SERVICE LETTER 222

Maule 2350A & 3000A Hydraulic Pump Replacement

Aircraft Makes/Model(s):	Float Model(s):	Compliance: Optional	By: MAB
Maule MX-7-180B, MX-7-180C, MX-7-235, MX-7-420, MXT-7-180,		Part Number: 1011615	Approved: SDW
M-6-235, M-7-235, M-7-235B, M-7-235C, M-7-260, M-7-260C, M-7-420A, M-7-420AC, MT-7-260, MX-7-235	2350A 3000A	Date: 5/7/2021	Revision: A

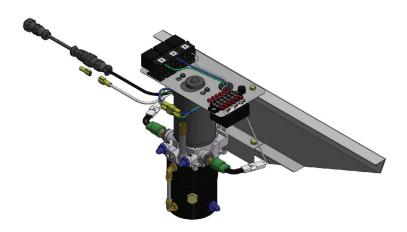
DISCONTINUED 12 VDC
HYDRAULIC PUMP 23A09000-225

NEW 12 VDC HYDRAULIC PUMP 1011611

The 12 VDC Hydraulic Pump Assembly p/n 23A09000-225 and the 24 VDC Hydraulic Pump Assembly p/n 23A09000-276 have both been discontinued. This service letter provides the option to replace them with a 12 VDC pump p/n 1011611 or with the 24 VDC pump p/n 1011612.

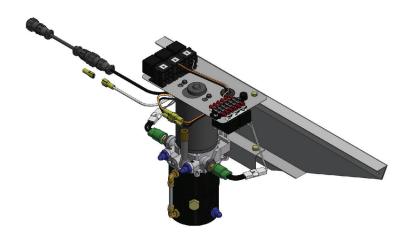
DISCONTINUED 24 VDC
HYDRAULIC PUMP 23A09000-276

NEW 24 VDC HYDRAULIC PUMP 1011612

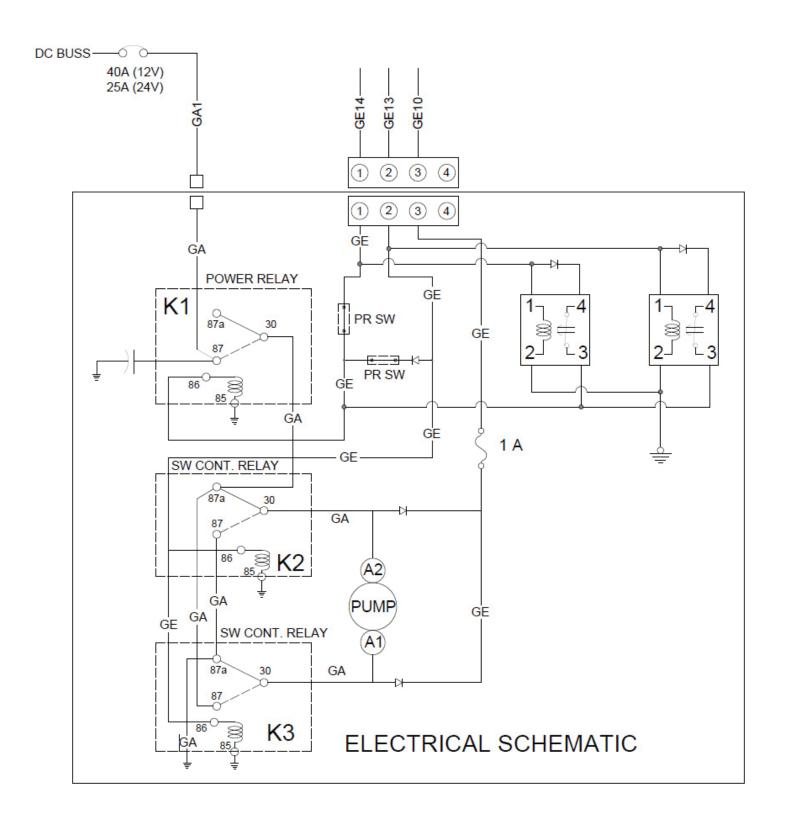
- 14. Cut single pin Molex connector from GA1 wire. Install 73F-250-32NL connector onto GA1 wire. Connect GA1 wire to power wire on hydraulic pump assembly. See electrical schematic.

- 14. Cut single pin Molex connector form GA1 wire. Install 73F-250-32NL connector onto GA1 wire. Connect GA1 wire to power wire on hydraulic pump assembly. See electrical schematic.
